Access Compliance Report Public Rights-of-Way (Curb Ramps)

Main Street: AUBURN_AVE Cross Street: STRATTON_WAY Location: SE

ADA ID: RPAT211006132453 Ramp Type: Type 6 - Directional 1 Initial Pass/Fail: Fail Overall Compliance: No Severity Score: 2

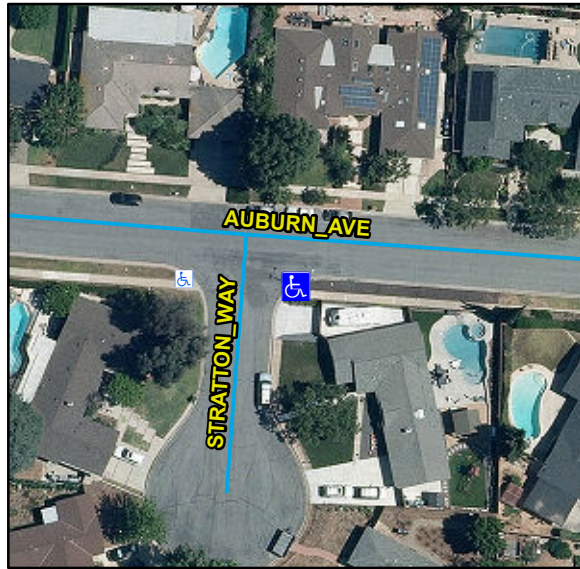
Compliance	Description	Data	Compliance	Description	Data
N/A	Ramp Length (in)	119	N/A	Flare Type LT	
Yes	Ramp Width (in)	48			N/A
Yes	Ramp Run Slope (%)	5.9	N/A	Flare Slope LT (%)	N/A
No	Ramp Cross Slope (%)	4.3	N/A	Flare Traversable LT	N/A
N/A	Grade Break	N/A	N/A	Flare Type RT	
N/A	Grade Break Slope (%)	N/A			N/A
N/A	Grade Break Cross Slope (%)	N/A	N/A	Flare Slope RT (%)	N/A
	Addl Para Ramp Left?	No	N/A	Flare Traversable RT	N/A
	Addl Para Ramp Right?	No	N/A	DWS Provided	N/A
N/A	Landing Present	N/A	N/A	DWS Contrast	N/A
N/A	Landing Length (in)	N/A	N/A	DWS Length (in)	N/A
N/A	Landing Width (in)	N/A	N/A	DWS Full Width	N/A
N/A	Landing Run Slope (%)	N/A		DWS Offset Type	N/A
N/A	Landing Cross Slope (%)	N/A	N/A	DWS Left Offset (in)	N/A
N/A	Landing Movement Obstructed?	N/A	N/A	DWS Right Offset (in)	N/A
	Landing Movement Type	N/A			
N/A	Landing Shared	N/A			
N/A	Marked Crosswalk 1	No	N/A	Clear Space	Yes
	Crossing 1 Direction	N	N/A	Clear Space To Crosswalk (in)	N/A

Remove & Replace Curb Ramp With Two New Directional Ramps or Equivalent.
